Docket Item # 6 & 7  
BAR CASE # 2009-0309 & BAR  
CASE # 2010-0002

BAR Meeting  
January 20, 2010

**ISSUE:** Addition, Alterations and Waiver of Rooftop HVAC Screening Requirement

**LOCATION:** 206 Duke Street

Figure 1. Plat showing proposed addition and shed.

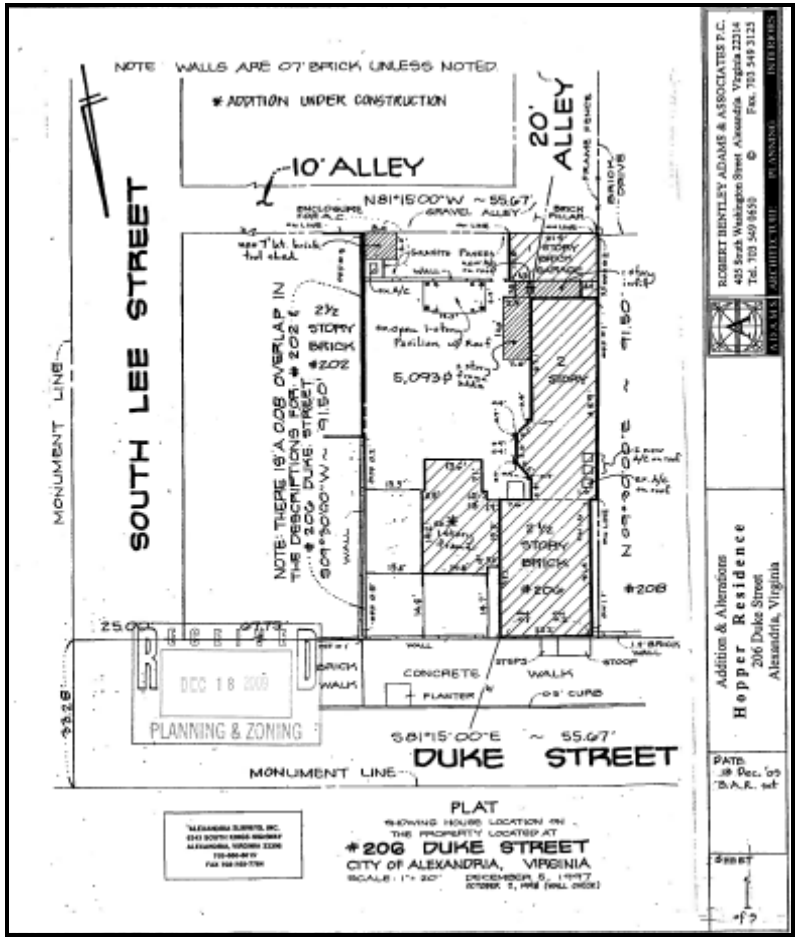
1. That the synthetic trim be solid-through-the-core and paintable;
2. That the applicant meet the five foot side yard setback on the east property line for the proposed HVAC condenser unit or obtain a waiver of this requirement from the adjacent property owner at 202 Duke Street; and

The proposed addition, alterations and storage shed, as well as the rooftop HVAC condenser units comply with the RM requirements of the Zoning Ordinance if the proposed HVAC condenser unit on the east property line is set back five feet or if the applicant obtains a waiver from the adjacent property owner at 202 Duke Street.

Figure 4. East elevation – existing and proposed.

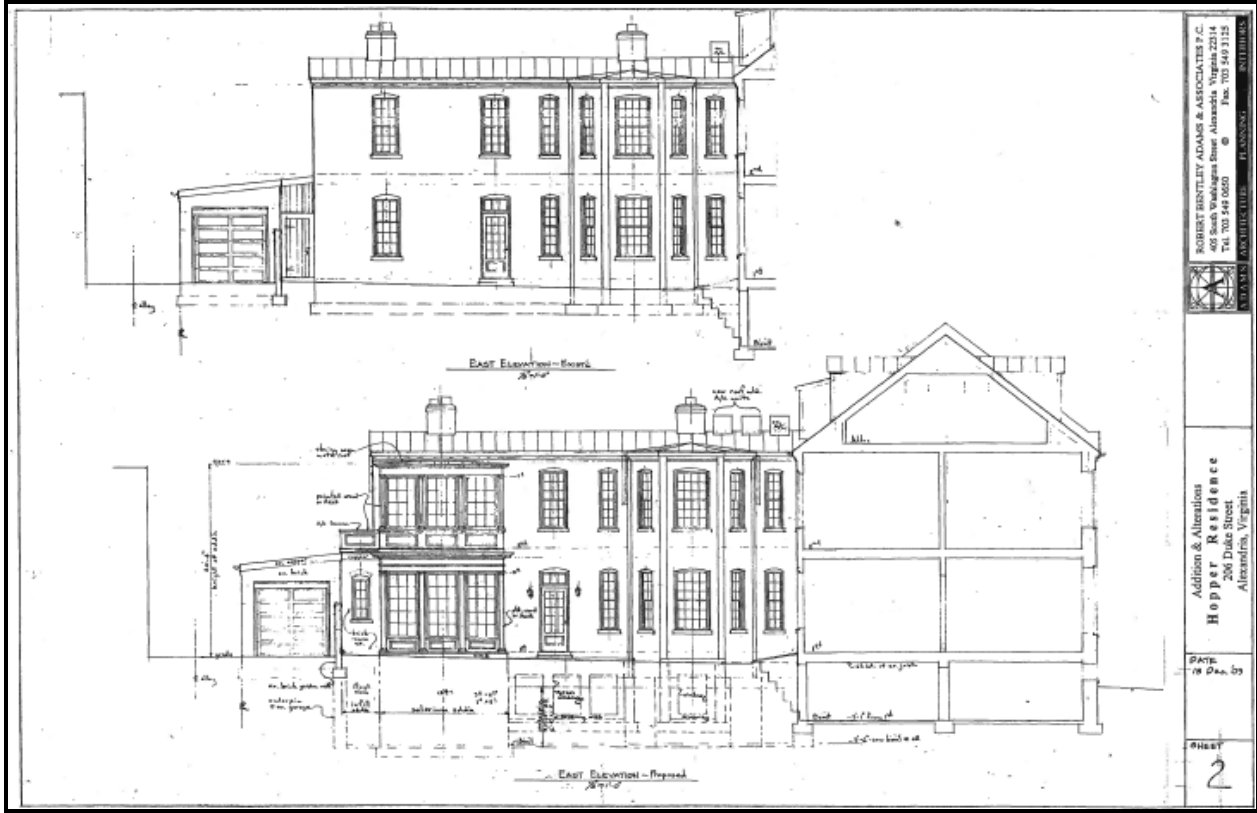
The proposed addition will have a two story component and a one story infill component. The two-story portion will project off of the east elevation of the ell and will measure 14 feet wide by 7 feet long and will have a height of 20 feet 4 inches. The east elevation will contain three multi-light windows on both the first and second floors, separated by pilasters. There will be a trim panel under each window. On the south elevation there will be two multi-light windows on the second floor. There will be a panel below the easternmost window; while below the other window there will be a paneled enclosure to screen the rooftop HVAC unit on the roof of the one story portion of the addition. The north elevation of the addition will contain two multi-light windows on each story, with a larger single panel below each window. The applicant has specified that the trim on the addition, including the pilasters and the trim panels, will be constructed of either Azek or wood. The low sloped roof of the addition will be clad with standing seam copper.

Although the *Design Guidelines* state that “The predominant building materials for residential buildings in the historic districts are wood and brick. The choice of building materials for residential additions should reflect these traditional materials”, the Board has typically approved the use of synthetic materials on new additions. The submission materials indicate that either Azek synthetic trim or wood will be used; however, the applicant has expressed a preference to use Azek trim due to its durability. While Staff would not recommend the use of synthetic trim on a historic building, Staff does not object to the use of Azek on those portions of the new addition. The addition is also sufficiently set back so that Staff does not believe that synthetic material would be decipherable. However, Staff does recommend that the synthetic trim be solid-through-the-core and paintable.
